1 – 6 Pratt Mews, London NW1 - Application No: 2016/7739/P

On behalf of my client, Formedge Limited, we hereby object to the creation of a roof terrace and insertion of a patio door into the north facing elevation of the residential and office development currently been constructed on the site above (hereinafter referred to as 'the Property')

Figure 3: Rear elevation of 6 Pratt Street (Listed Building)

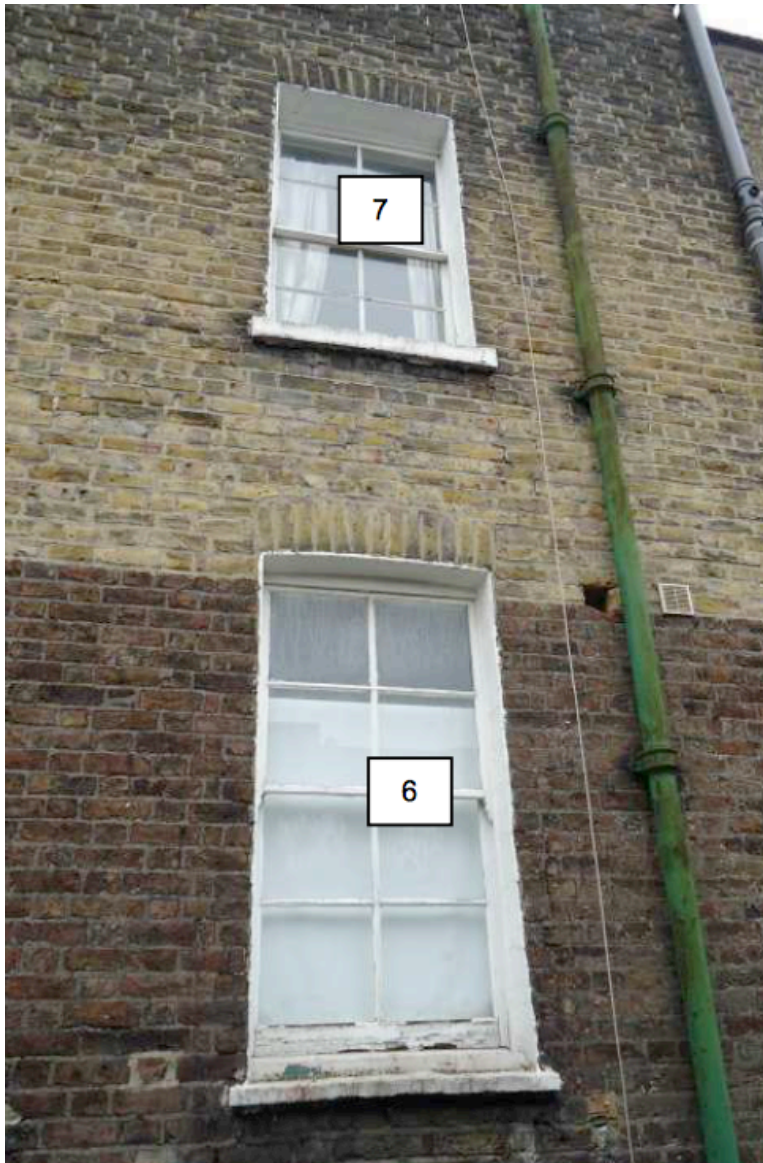
We believe there will be a negative impact for the occupants in terms of overlooking and loss of amenity from the creation of a roof terrace and patio door in the new development. Habitable room windows are located directly facing the Property and one in particular is located in a very sensitive location on the second floor of 6 Pratt Street. See an image below with the window numbered 7.

The second floor window is located marginally higher than the proposed roof terrace and within a distance of approximately 5 metres from the terrace. There will be views directly into this window from the roof terrace and patio door. The proposed privacy screen will not help mitigate the overlooking, because the window is located higher than the top of the screen. Regardless of this, the screen as proposed, has a negative impact on the outlook from my client's properties due its large and overbearing size and very close proximity. If it is made any higher, this impact will become worse, not only for the occupants of 4/6/6a Pratt Street but also for the occupants of the new apartment, Flat 5 in the Property.
